PRODUCT CHANGE NOTIFICATION

PCN No.: EC-20251210-PCN-01	**PCN Doc No.:** PCN-202512-002	**Date Issued:**	12/10/2025
Part Number or Series: PH2-XX-UA		**PCN Effective Date:**	12/10/2025
Customer: (If applicable)		**P/O No.: (If applicable)**	Not affected
Type of Change:	■ Mfg location Change / Qualification / Country of Origin (COO) ■ Design Change / Data Sheet Spec Change	**Last Time Buy Date:**	Not affected
Traceability Marking/Date code: No change		**Last Time Ship Date:**	Not affected
Replacement Part Number: PH2-XX-UA-HT-Y		**Sample Availability Date:**	Not affected

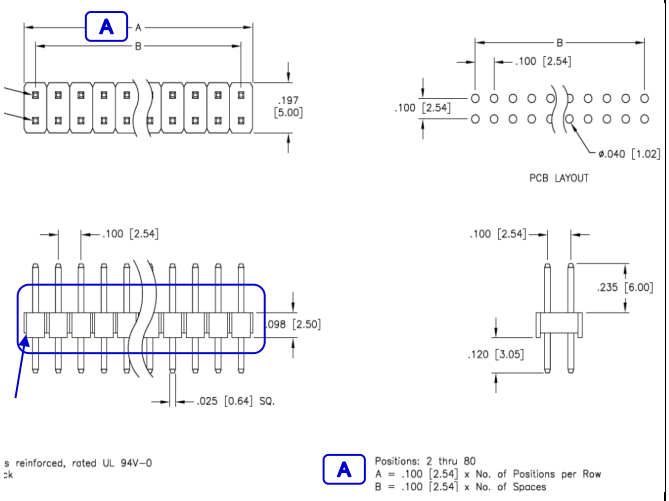
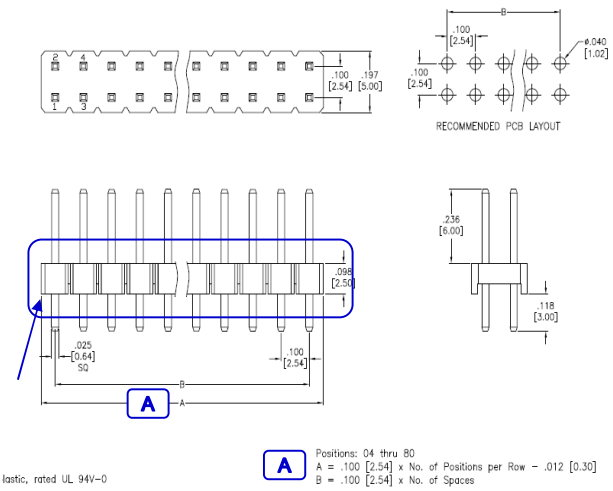
Impact of Change: P/N change, There are slight differences in appearance and size;	**Original COO parts still available:** Yes ☑ No ☐

Before the change:
1、Appearance ~ As shown in the above picture;
2、Size:
A) A=.100[2.54] * No. of Positions per Row

After the change:
1、Appearance ~ As shown in the above picture;
2、Size:
A) A=.100[2.54] * No. of Positions per Row - .012[0.30]
